Addendum No. 1 to IFB 17-52

To: All Parties on Record with the City of Somerville as Holding IFB 17-52,
Hoyt Sullivan Park

Re: Answer questions posed at pre-bid site visit, update electrical drawings, attach pre-bid
site visit attendance list

E1.1

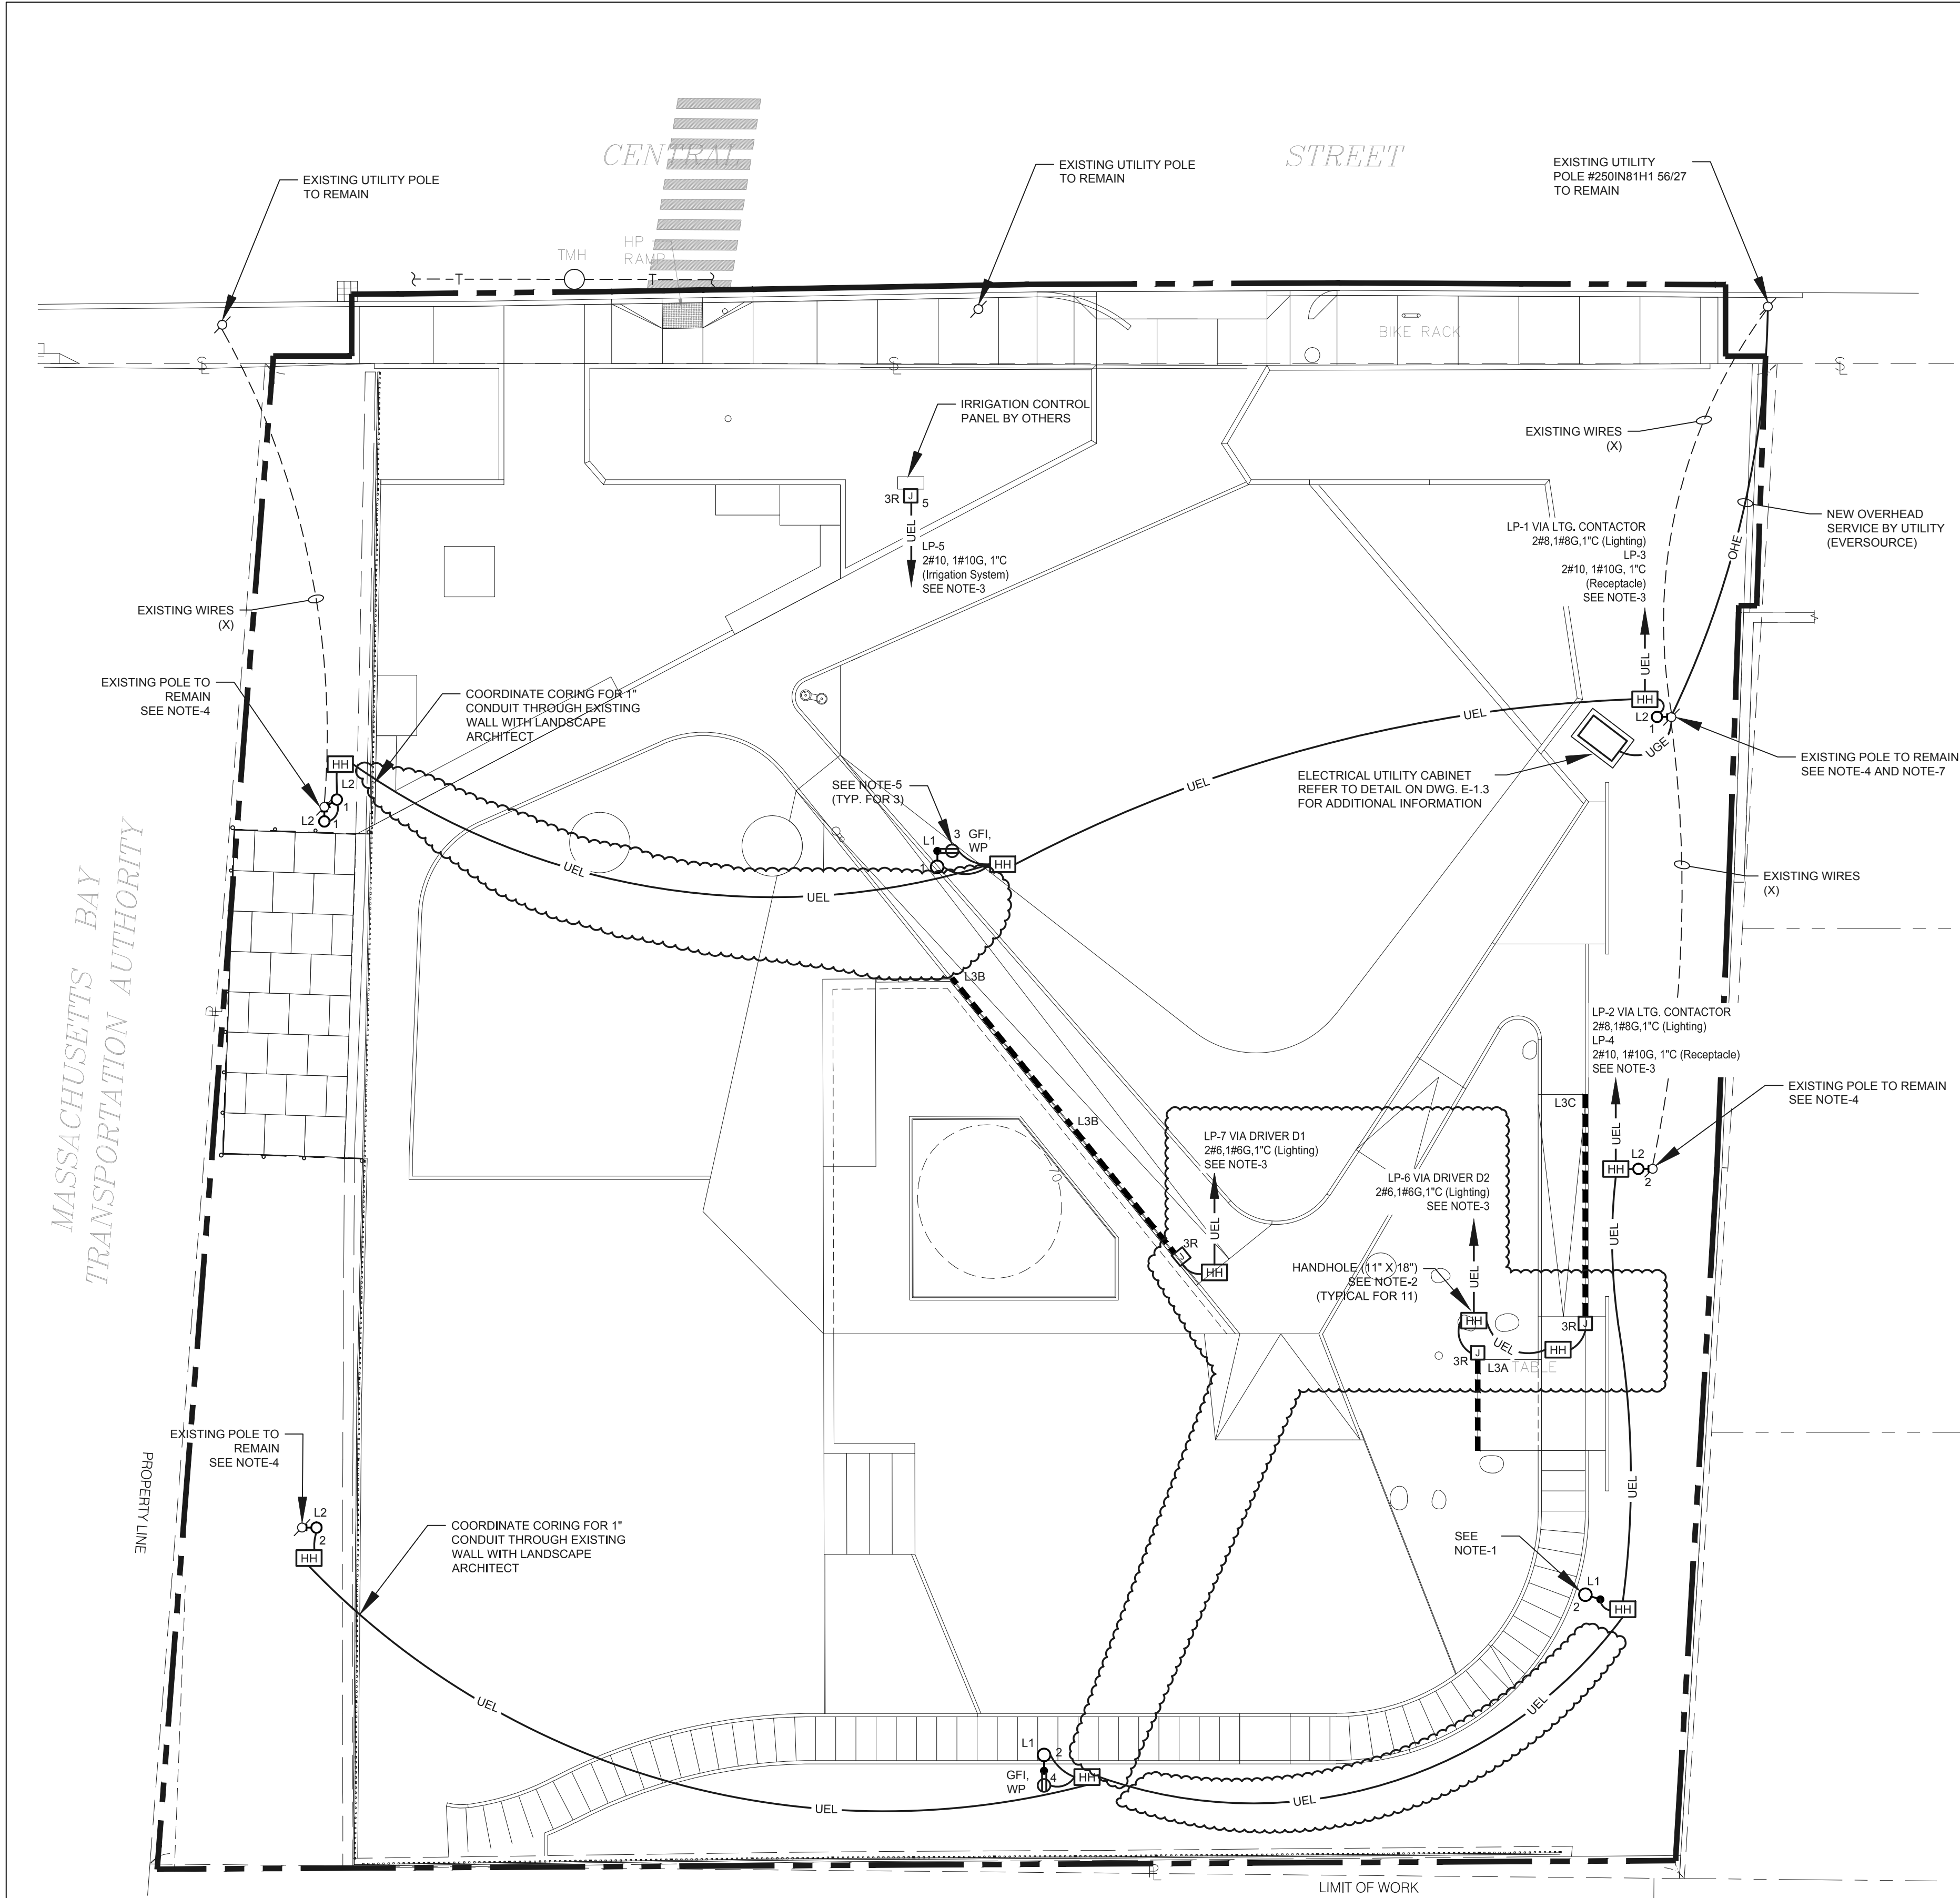
5) Q. Can you speak to the electrical and lighting?

A. The electrical drawings are being reissued as part of this addendum. Lighting scope includes new pedestrian poles and fixtures and new fixtures on existing poles, as well as LED tape lights. See E1.1 and E1.2
